Cala Homes

Land at Fiery Hill Road

Highways Review

Job Title	Land at Fiery Hill Road		
Job Number	J322540	Date	15/12/2015
Copy	Copy	File reference	151112 322540 AY
Prepared by	Alan Young	Approved by	David Frisby
Subject	Highways Review

CALA House Arleston Way Solihull B90 4LH Tel: 0121 711 5310 Fax: 0121 711 5311	
Site: Land off Fiery Hill Road Barnt Green			
Drawing Title: Fiery Hill Road Realignment Visibility to Vehicle Track			
Drawing No: M00311\S278\101			
Revision: -		Scale: 1:500 @ A3	
Date: 24.11.2015		Drawn: CB

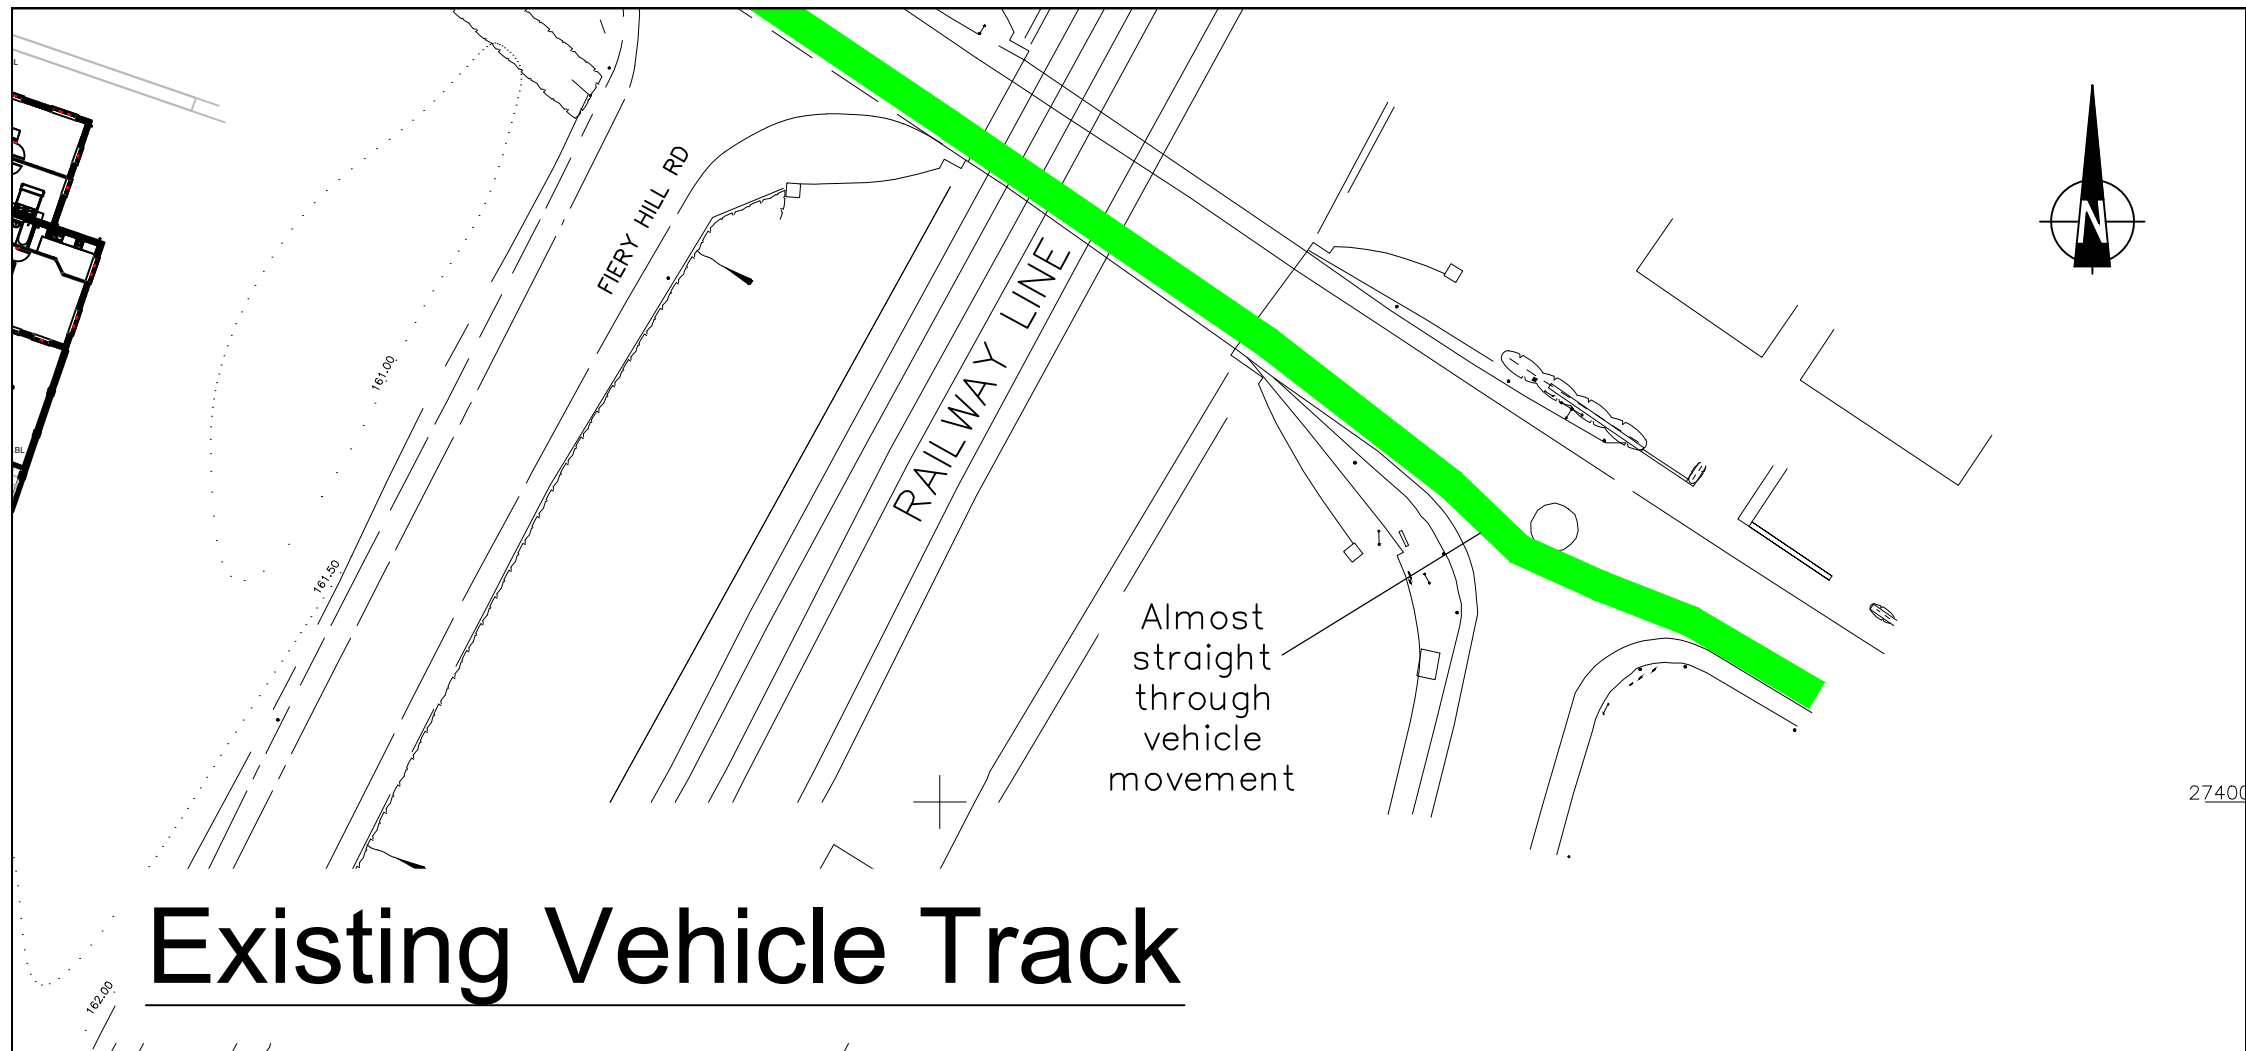
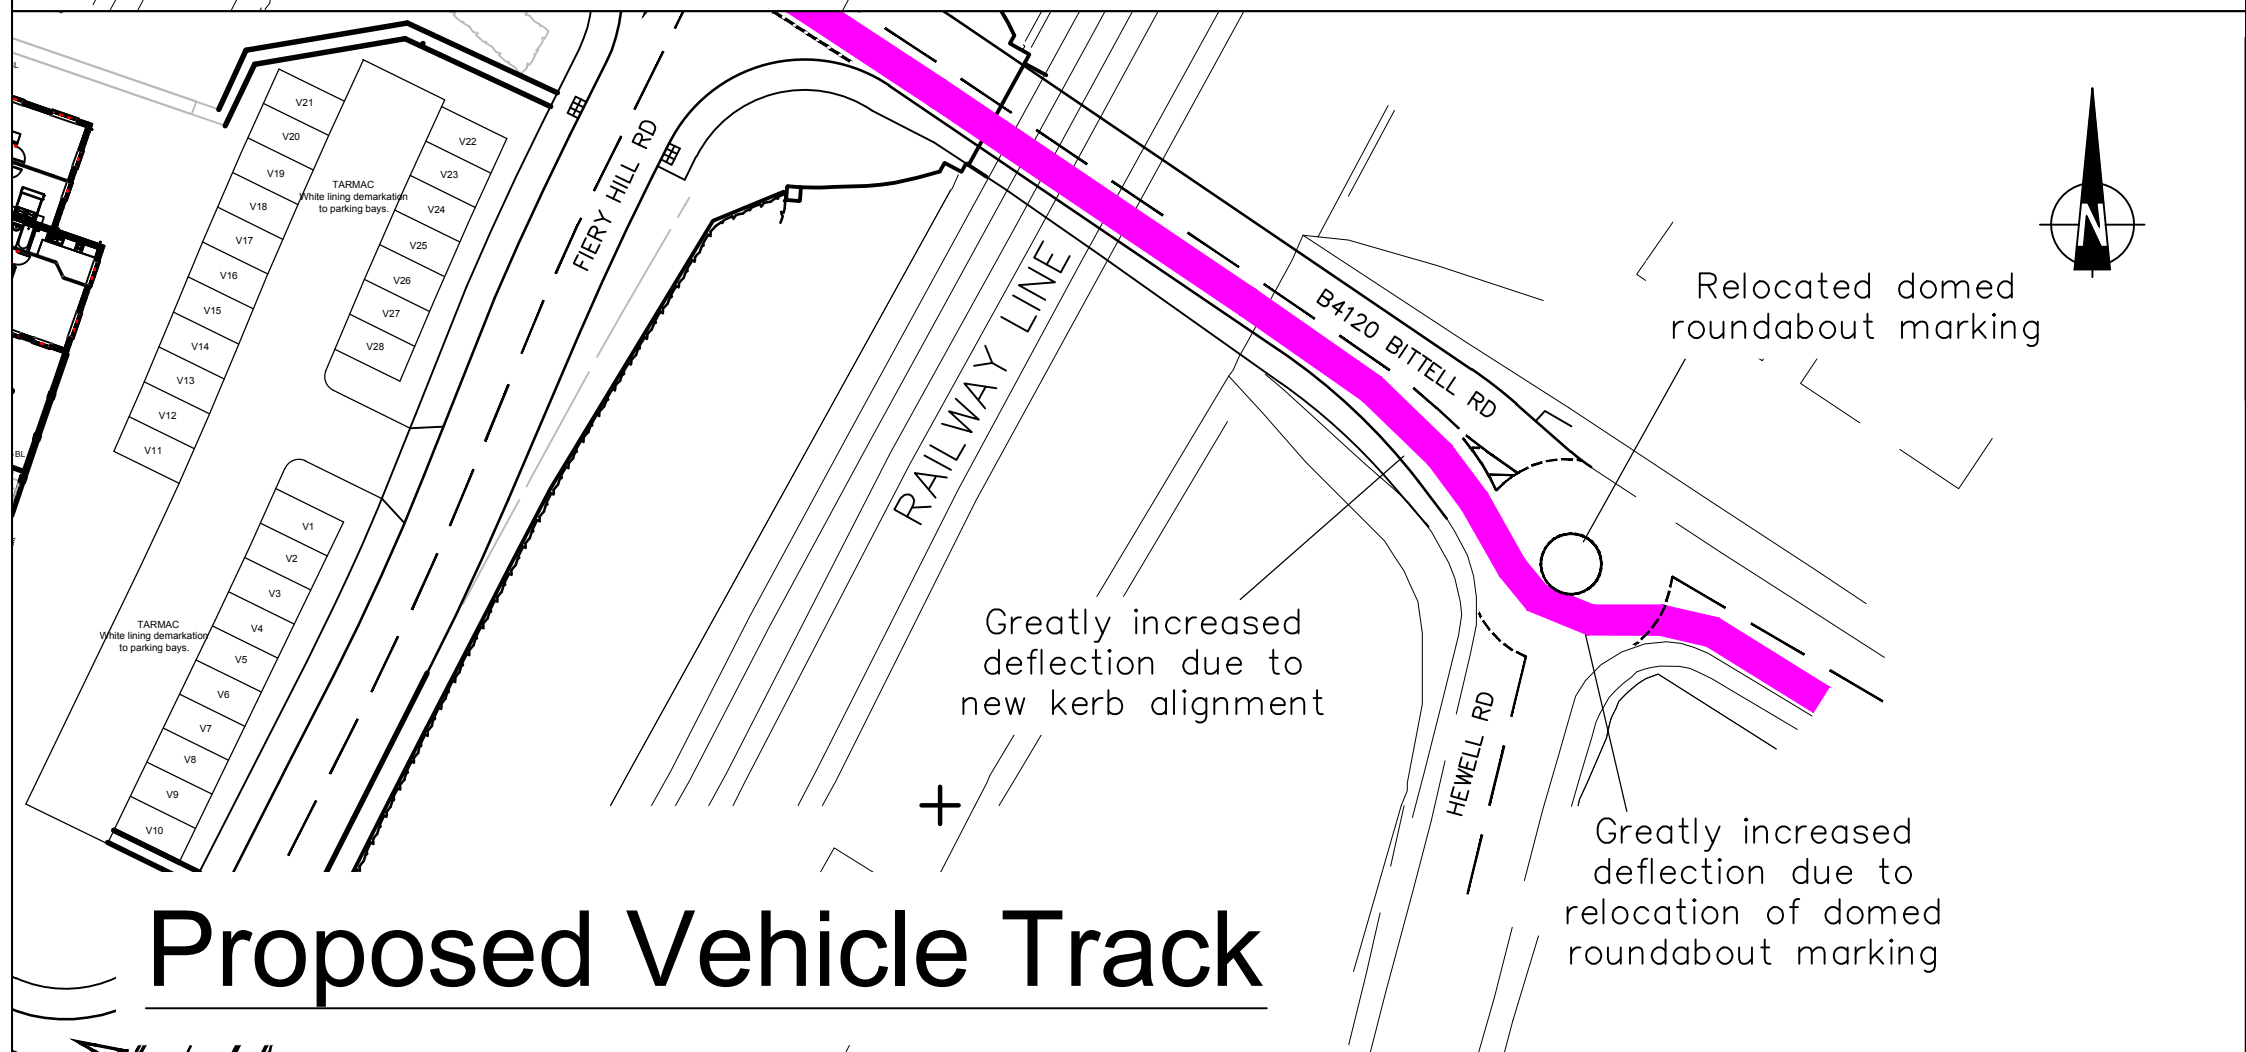
- 2.2 *“Manual for Streets”* allows for an increase in the Y-Distance element of the visibility splay over that previously used, by measuring to the near side running track of the carriageway, approximately 1m from the kerb (ref; MfS2 page 76 and MfS2 para 10.5.3). In paragraph 10.5.3 MfS2 states, *‘Therefore a more accurate assessment of visibility splay is made by measuring to the nearside edge of the vehicle track.’* The argument being that drawing visibility splays to kerbs was always a matter of convenience for design purposes and that in reality cars and motorcycles do not physically drive along the kerb. Furthermore, MfS1 and MfS2 contain formula to be applied to the actual measured speeds at a specific location rather than having to rely on a speed limit.

- 2.3 A recent speed survey conducted at the site (11th to 17th November 2015) gives a 7 day 85th percentile speed of just 27mph for vehicles approaching the Fiery Hill Road junction from the bridge. Applying the MfS formula to this speed gives a Y-Distance of 34.5m. Measuring out 1m from the kerb would increase the current 20m Y-Distance referred to above to an achievable visibility of 30m, just short of the 34.5m required by MfS.
